**CALIFORNIA COASTAL COMMISSION**

**STAFF REPORT: PERMIT AMENDMENT**

**APPLICATION NO.:** A-5-RPV-93-005-A13

**PROPOSED AMENDMENT 13**

Exhibit 17

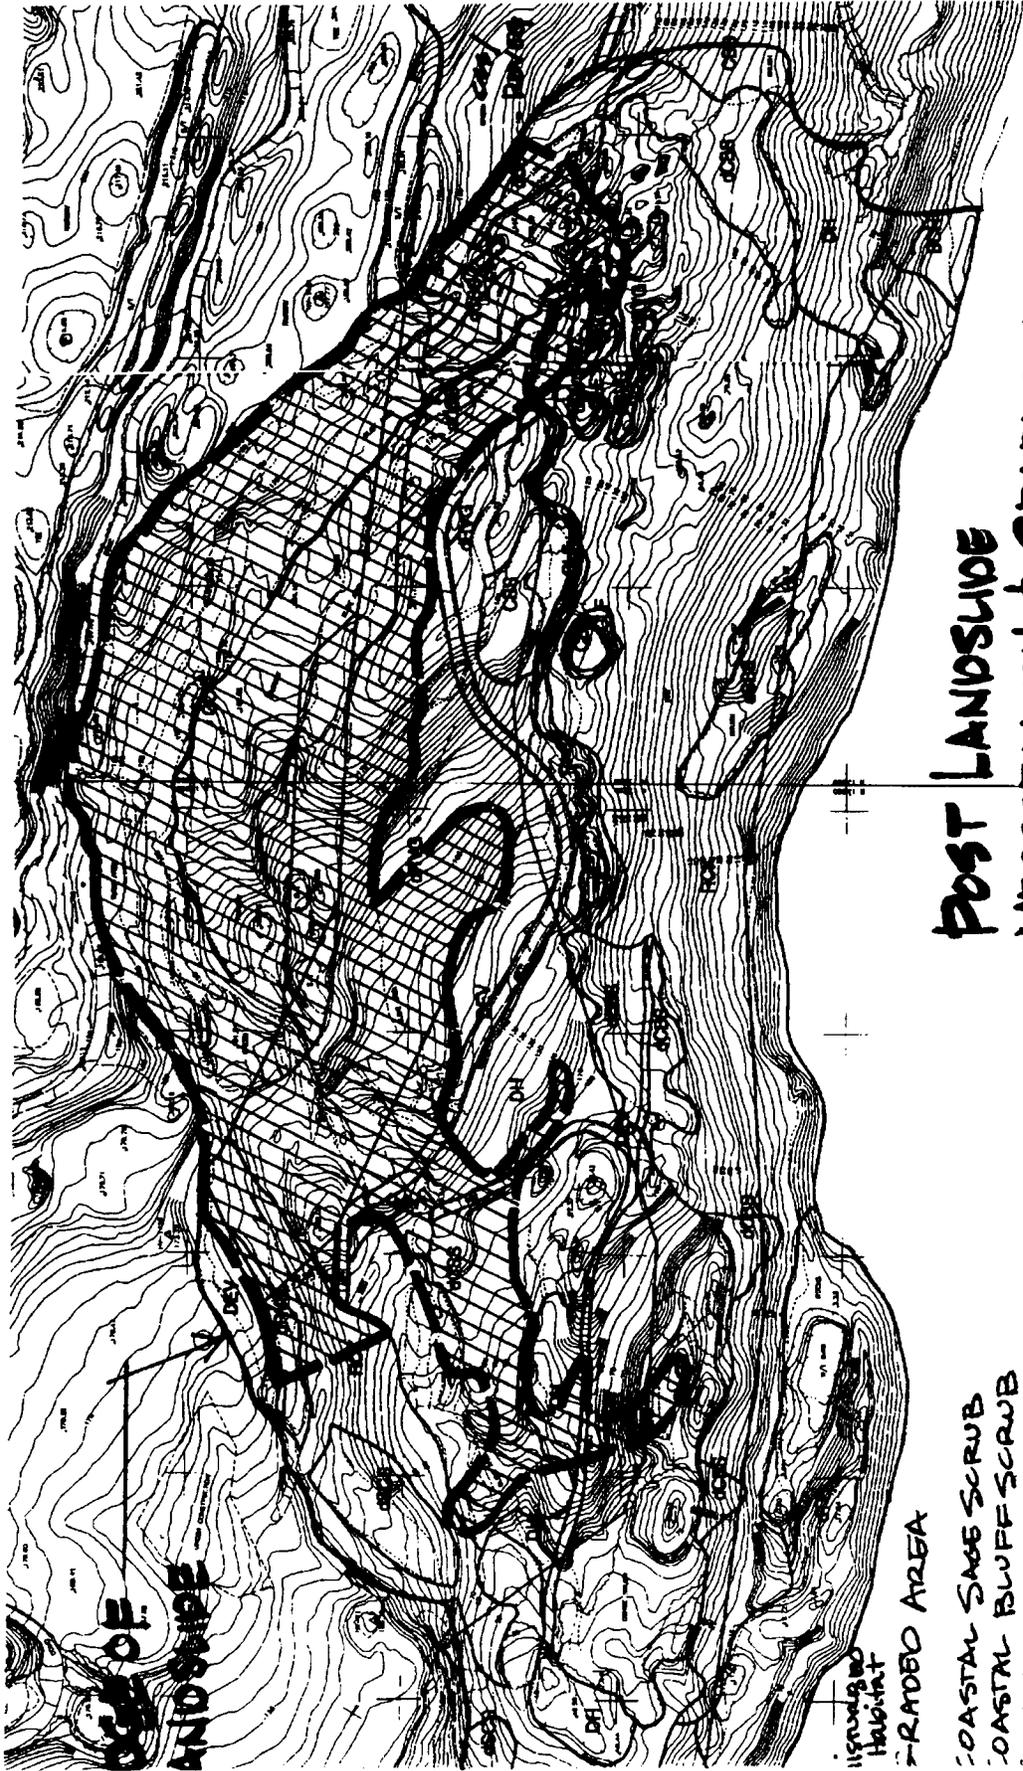
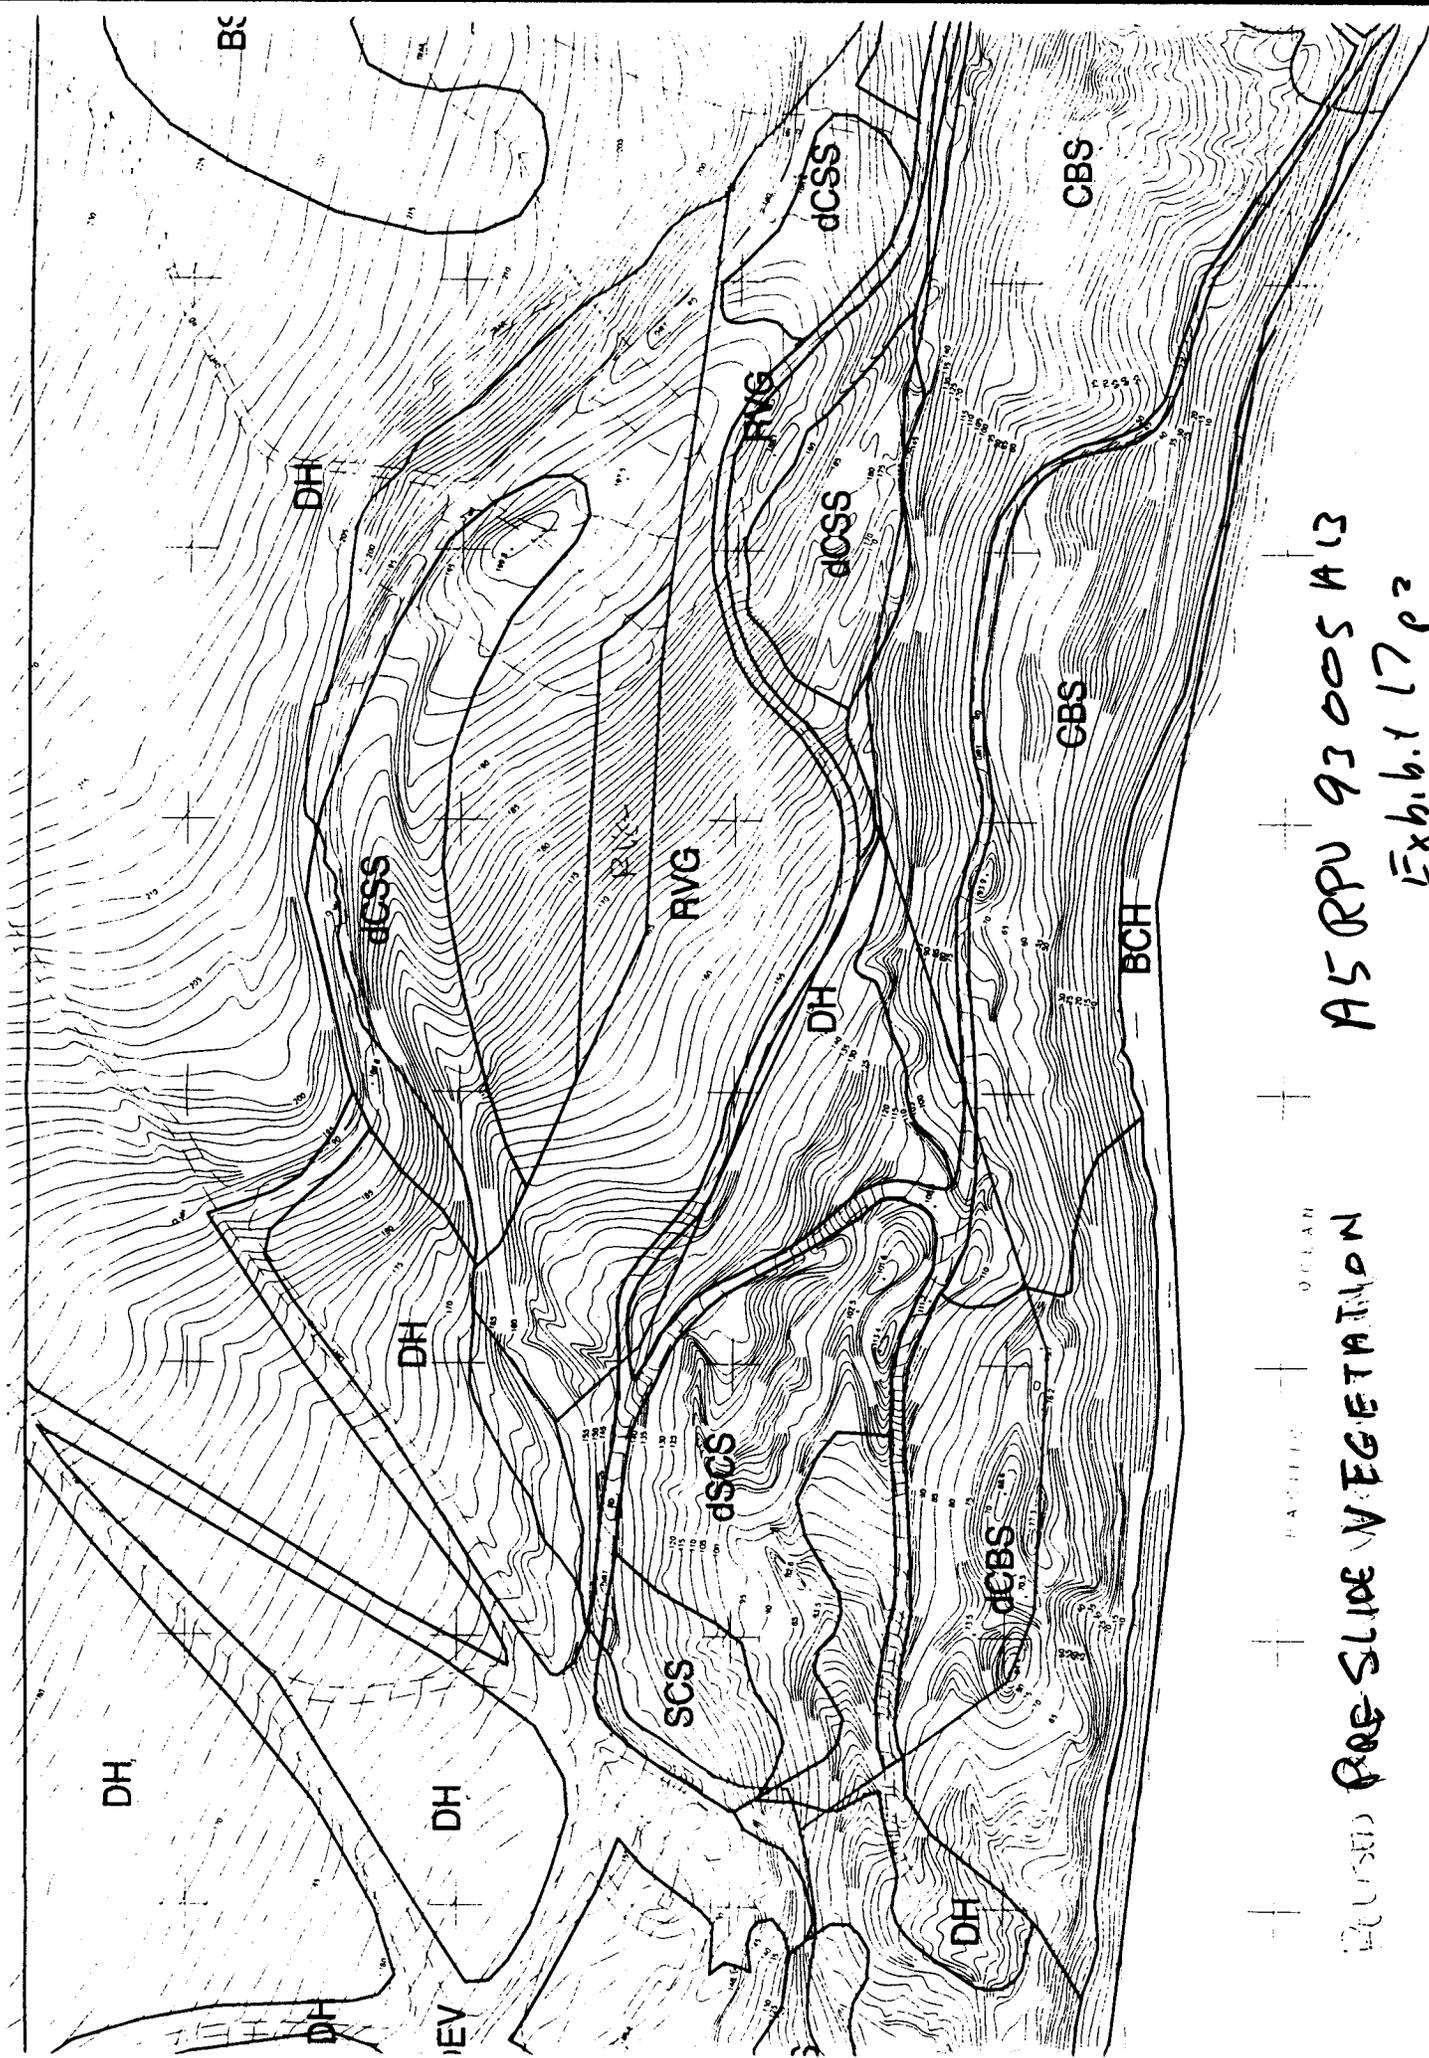
- 4) **All equipment access routes, and stockpile areas shall be located on the golf course, Halfway Point Park and the disturbed area of the slide block as shown in exhibit 17. All silt and runoff from the stockpiles and the disturbed graded areas of the site shall be controlled and confined within the site. Pursuant to this requirement, prior to issuance of permit amendment 13, the applicant shall provide erosion control plans for the review and approval of the Executive Director. Said plans shall be approved in advance by the City of Rancho Palos Verdes and conform to all conditions of this permit.**

- 1) Drilling and grading for geologic exploration within the already disturbed Bluff Top Corridor Area on slide C as shown in exhibit 17, within the golf course, and within 25 feet of the "limit of excavation" as shown on exhibit 7, provided that no drilling or grading removes established plants identified as critical habitat or as rare and endangered by the Department of Fish and Game. Installation of safety fencing and access control.**
